Tauranga City Council
21 Devonport Road
Tauranga 3143
New Zealand

BC330131 Request for Further Information #3 - Category 1 Geo-Professional Review

Awaiti Project Geotechnical Investigation and Desktop Summary Report

Mauao Viewing Platform	Mauao viewing platform.gsz Existing seismic	Job Number: 4280807	Date: 13/04/2023
			Scale: 1:50	4280807-GA-K005

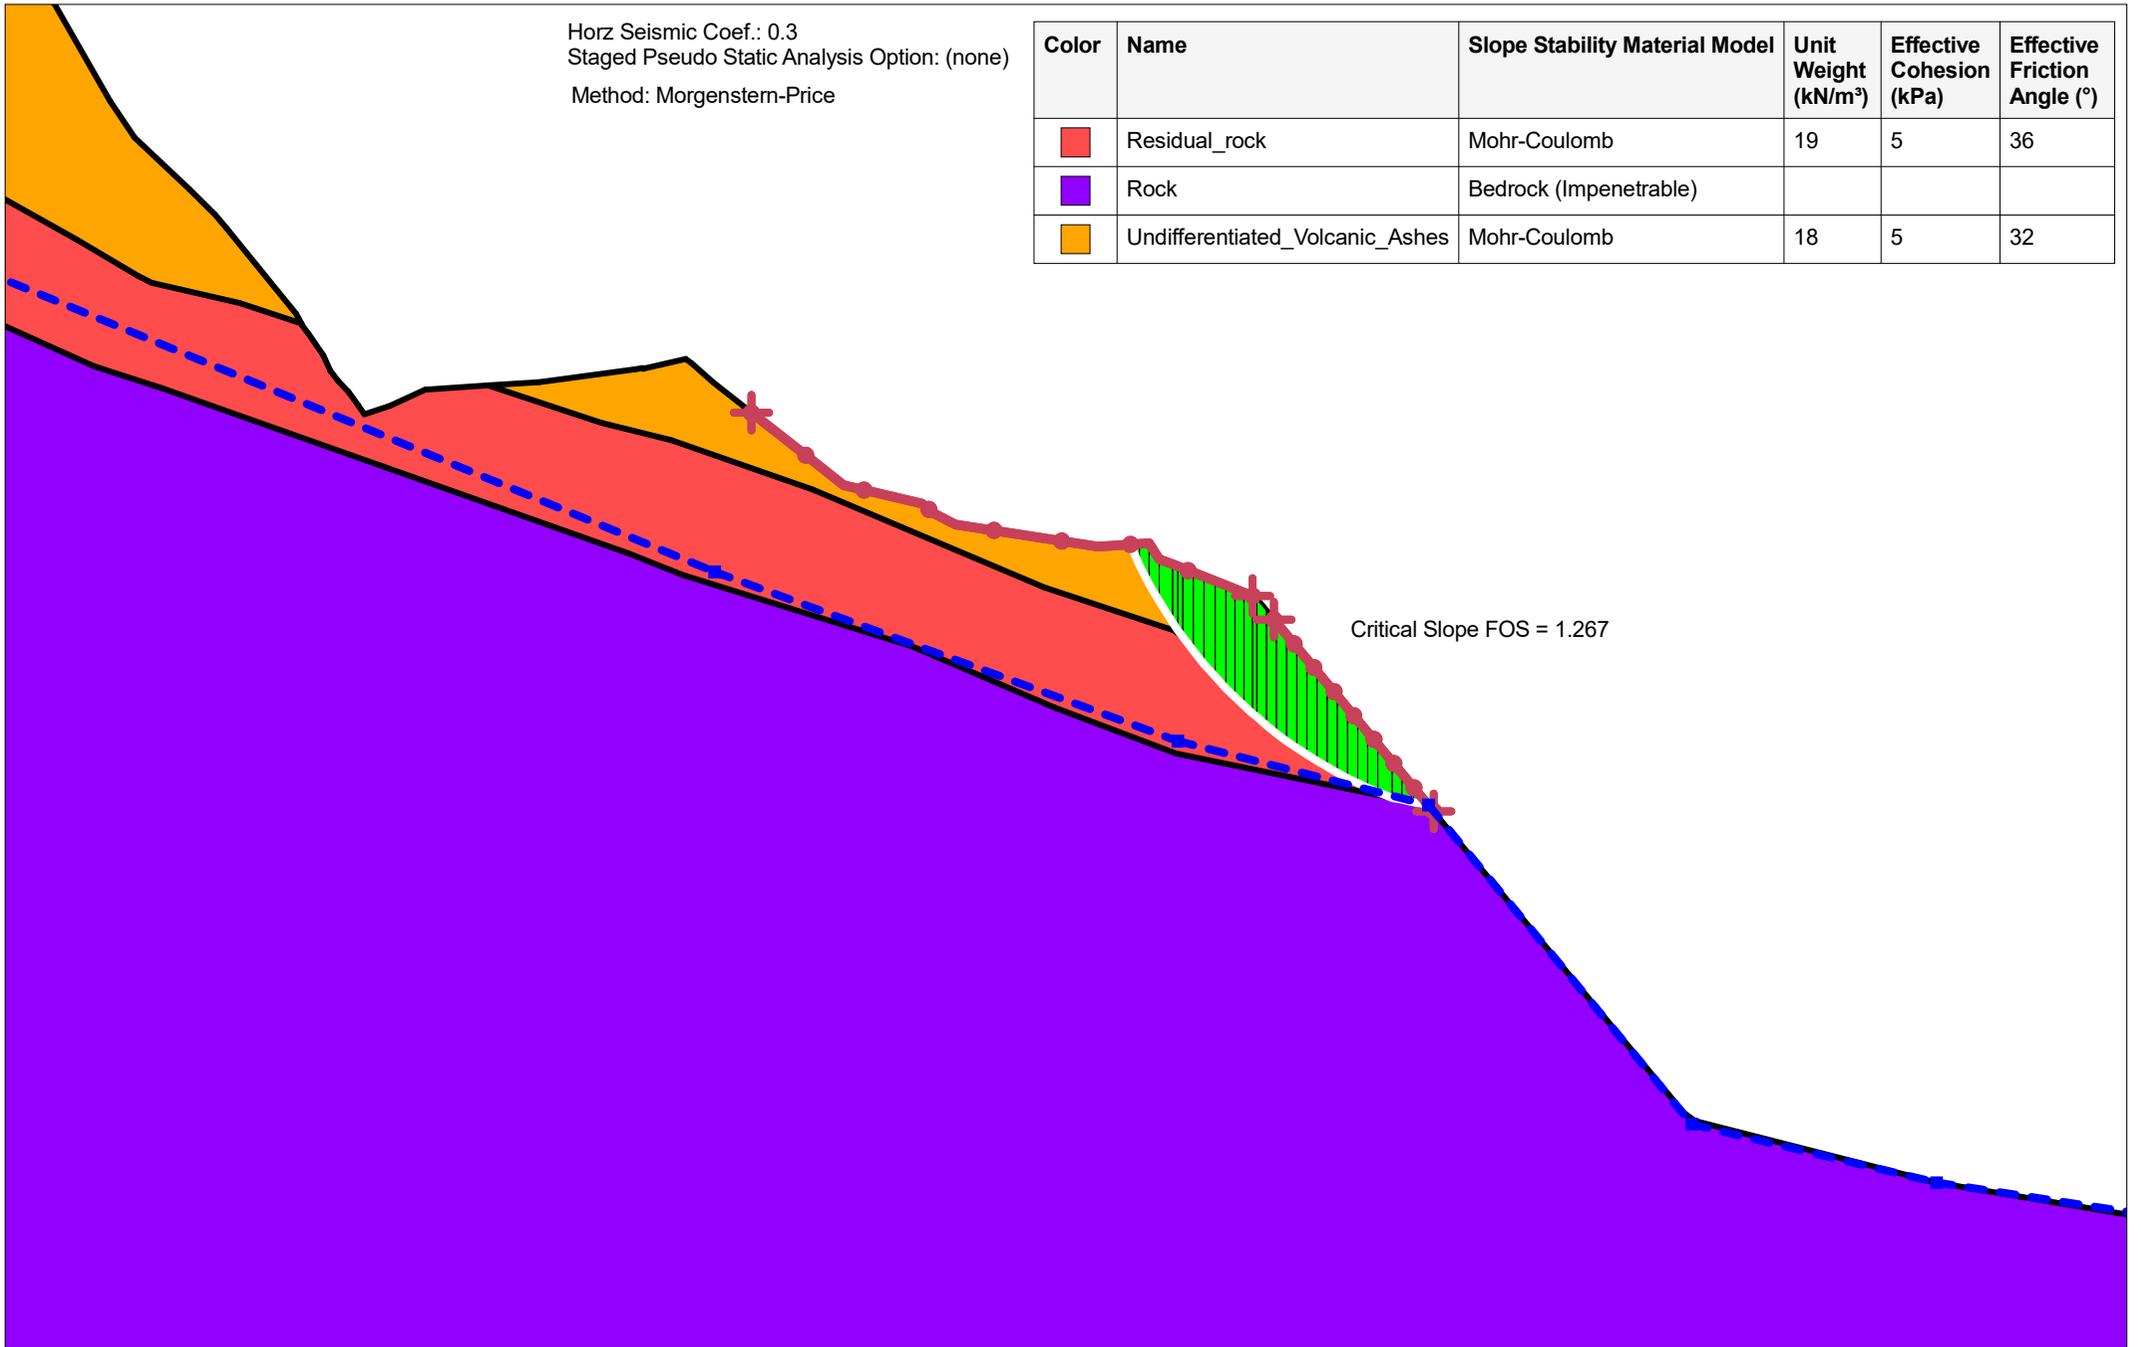
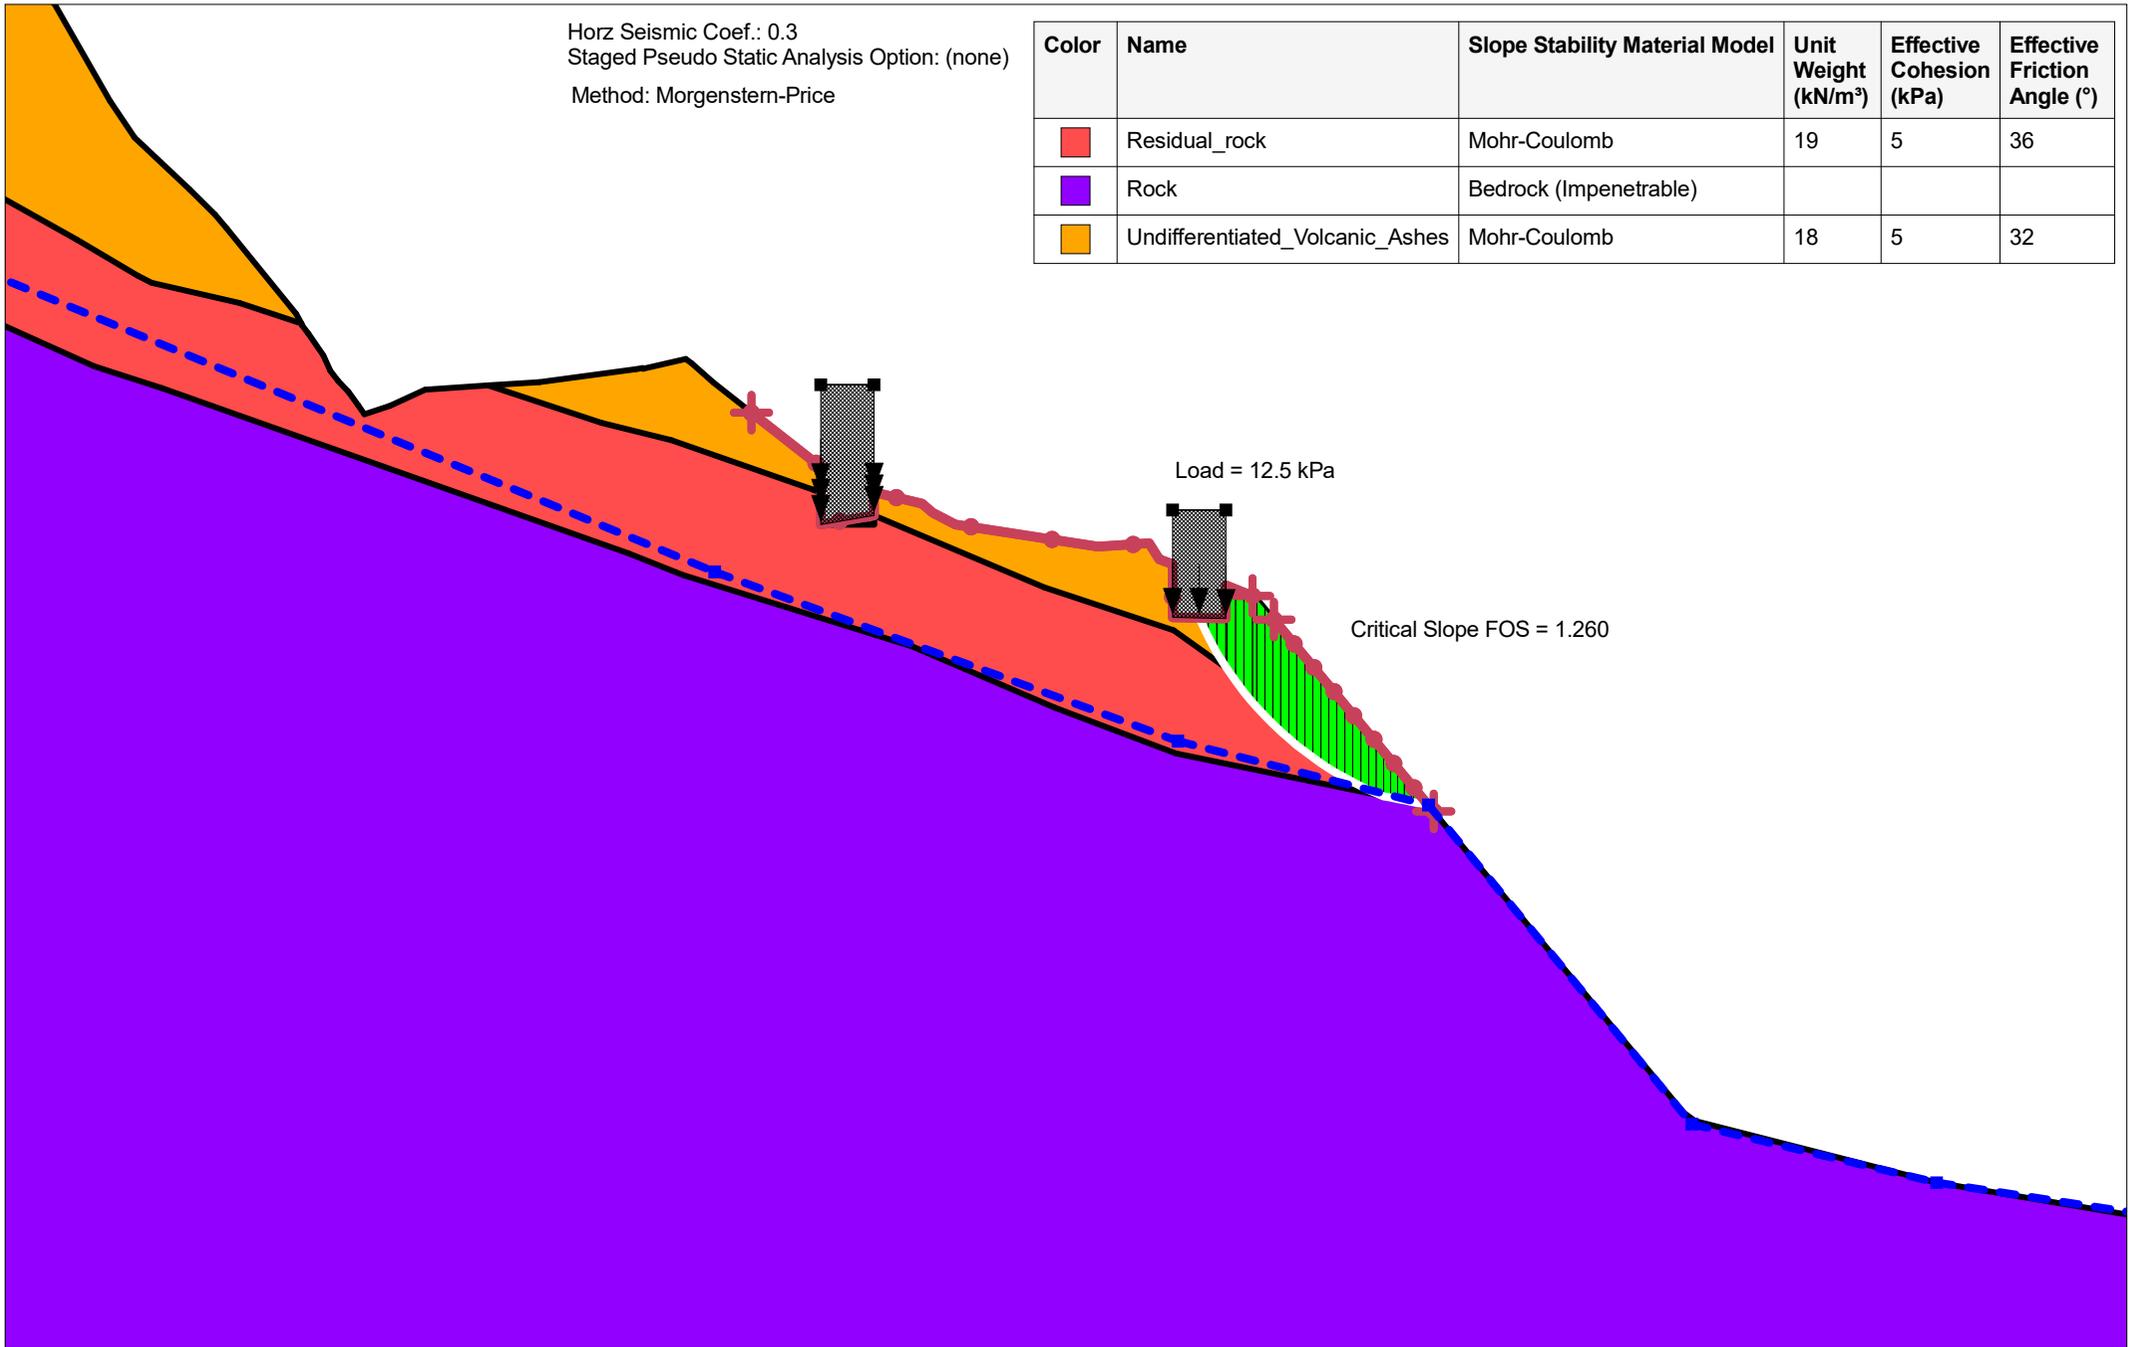
Question 1: Provide a review of the Beca geotechnical report dated 30/9/2022 from a Category 1 Geo-Professional and include a S72 assessment in respect to land stability.

We carried out analyses for the existing conditions and with the proposed structure. The results of the analyses are summarised in Table 1 below. In all cases the slope stability meets the minimum requirements of TCC IDC DS-10.

Case	Minimum Factor of Safety required	Existing	Proposed	Requirements met?
Static	1.5	1.87	1.54	Y
Extreme groundwater level	1.2	1.47	1.22	Y
Seismic	1.0	1.27	1.26	Y
